**Transition to 10 CFR 50.48(c) - NFPA 805  
Performance-Based Standard for Fire Protection for  
Light Water Reactor Electric Generating Plants, 2001  
Edition**

**Transition Report**

**Revision [#]**

Figure 4-1 - Fundamental Fire Protection Program and Design Elements Transition Process [Based on NEI 04-02 Figure 4-2/FAQ 07-0036]

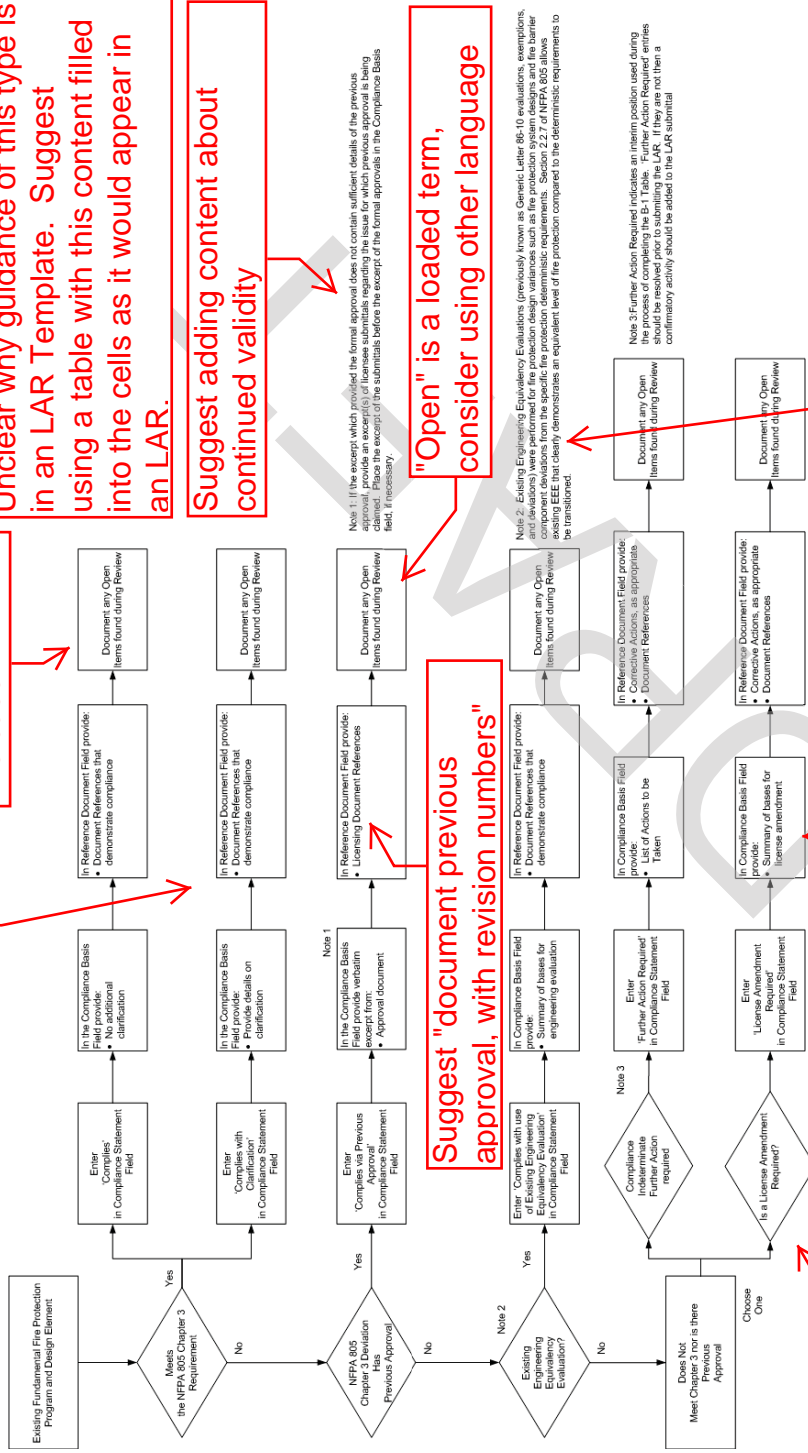
**Comment [EK2]:** Note Figure 4-1 also depicts a 'Further Action Required' decision. This indicates an interim position used during the process of completing the B-1 Table. 'Further Action Required' entries should be resolved prior to submitting the LAR. If they are not a confirmatory activity should be added to the LAR submittal.

This bullet is unclear. What compliance strategy is at issue? It should be clear that the LAR is requesting explicit approval. Same comment for Figure 4.1 bottom line.

This flowchart does not include an option for bringing a VFDR into compliance through modification

Suggest adding notes that EEE's are not involved in PB compliance strategies

Figure 4-5 Manage Risks

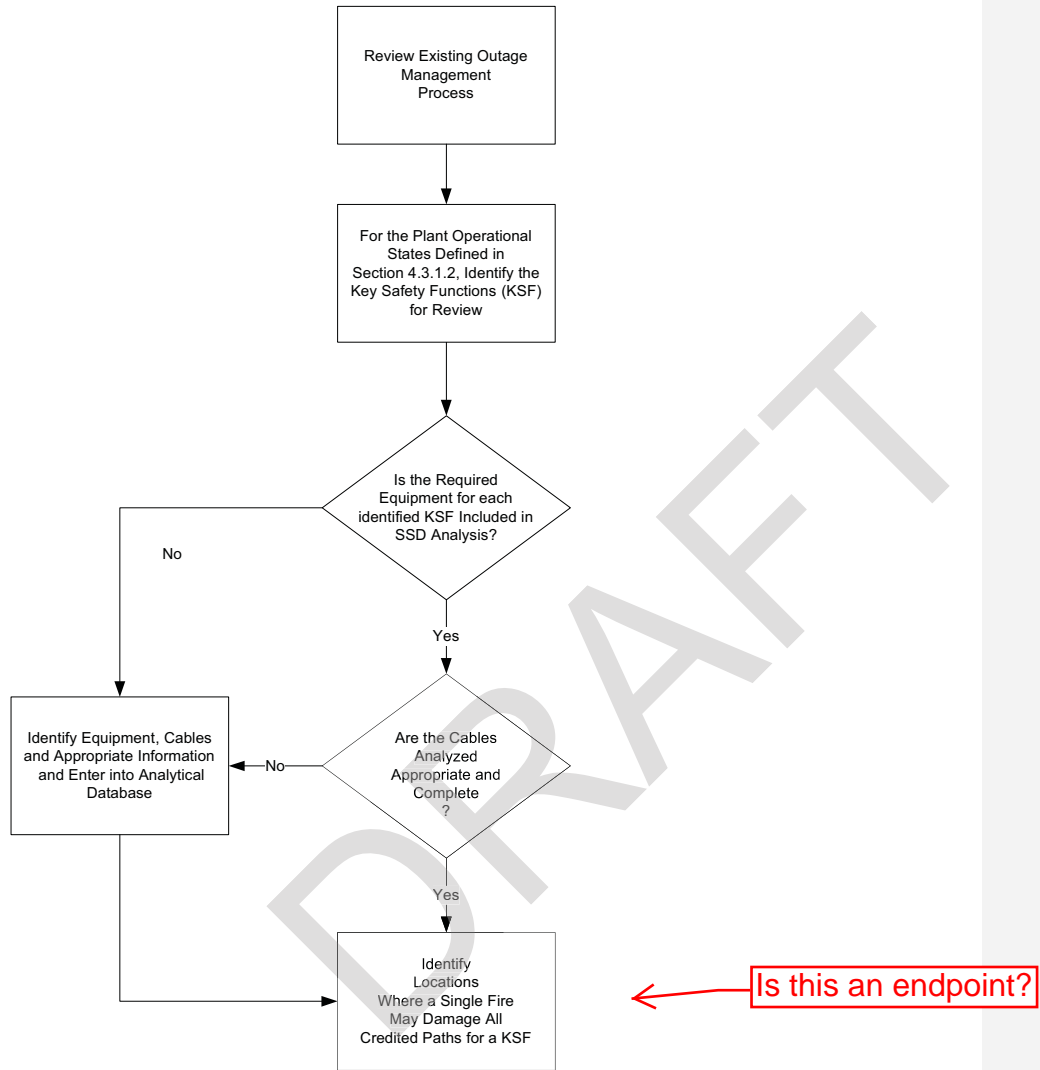
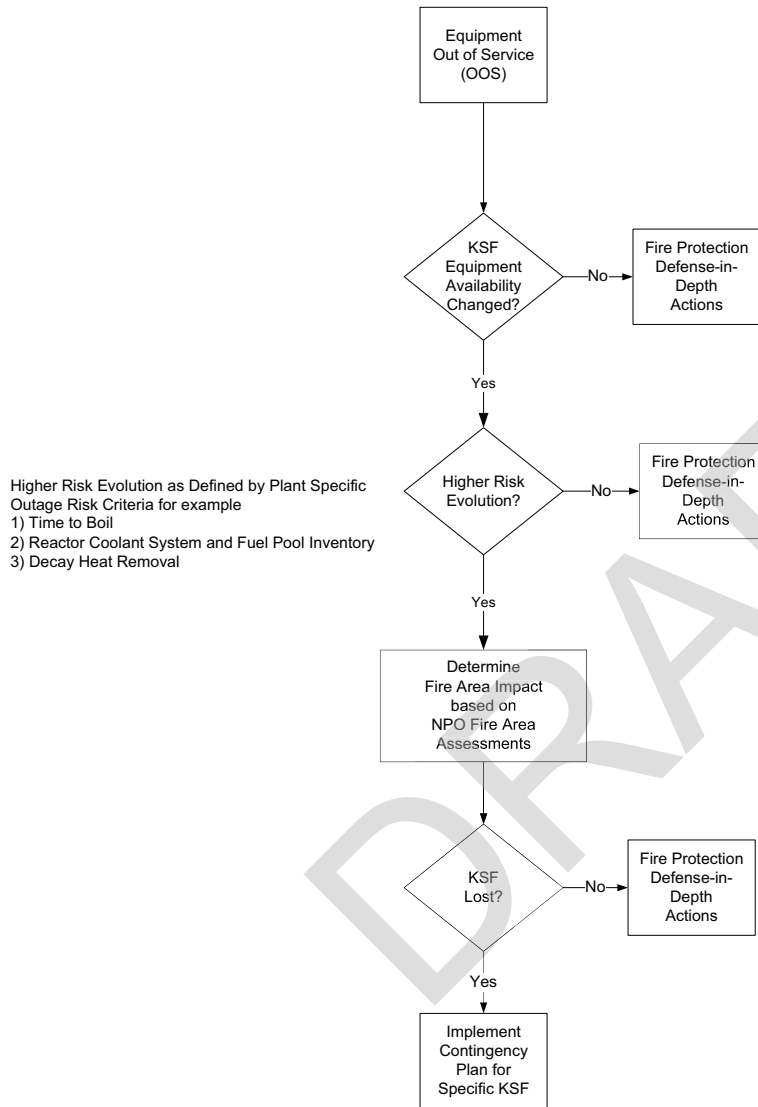
Not in  
template  
style.

Suggest not using "risk" Perhaps use "pinchpoints" or "events" instead

**Figure 4-8 – Multiple Spurious Operations – Transition Resolution Process (Based on FAQ 07-0038, Revision 1)**

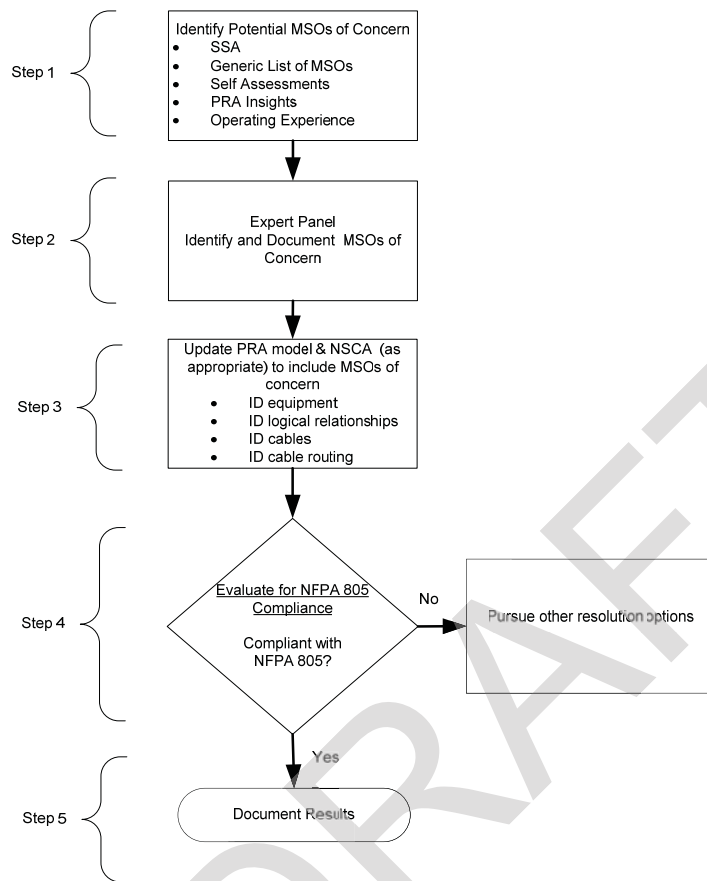
Comment [EK18]: Review RAIs for updates

A draft FAQ is referenced. A LAR would need to provide a site-specific justification to use a draft FAQ.
